September 28, 2020

Reference: Response to Supplemental Peer Review Comments
Application for Site Plan Review
27 Charge Pond Road PV+ES Project
Wareham, Massachusetts
B+T Project No. 1833.109

GRAVEL ACCESS ROAD

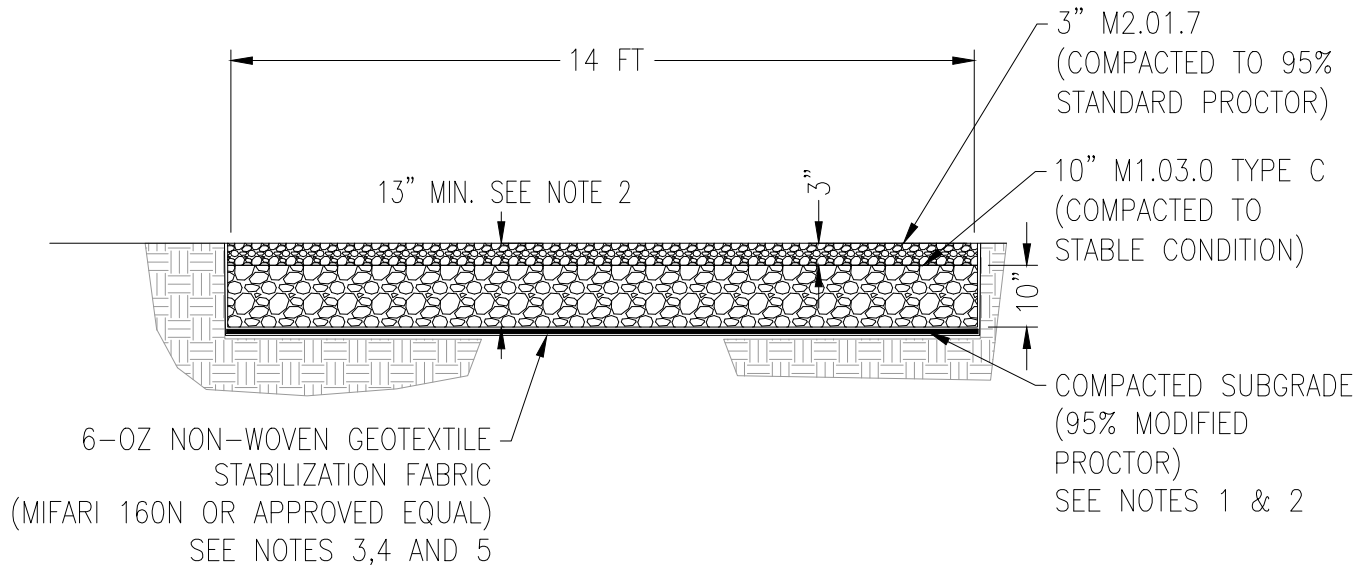
3. *The section through the proposed gravel access road shows it to consist of an 8-inch depth of 3 inch minus stone underlain by filter fabric. However, there is no indication of what is intended by "suitable material for subgrade". It should not be left to the contractor to make this decision.*

- 4. The grading plan shows that the road surfaces would pitch slightly toward the lower side slope. This may be sufficient to provide for good drainage without cutting in swales on the up-hill side. Using the stone and filter fabric could reduce the impact of additional surface runoff, thereby reducing the need for infiltration areas. Since this type of cross section is not a typical gravel road, the runoff curve numbers for it could be much less than 96 as provided in the storm water calculations.*

The detail for the gravel access road included on Sheet C5.0 of the plans requires 95% compaction for the proposed subgrade. The Applicant agrees to make the following modification to Note 1 on the civil detail in the construction drawings: "Subcontractor shall remove all topsoil, subsoil, organic and deleterious material for roadway subgrade."

The Applicant acknowledges this comment, but notes that the calculations were prepared in compliance with the curve number for gravel as defined by TR-55 – Urban Hydrology for Small Watersheds. An updated gravel road detail clarifying the roadway surface material and specification has been provided with this letter and will be included on the construction drawings.
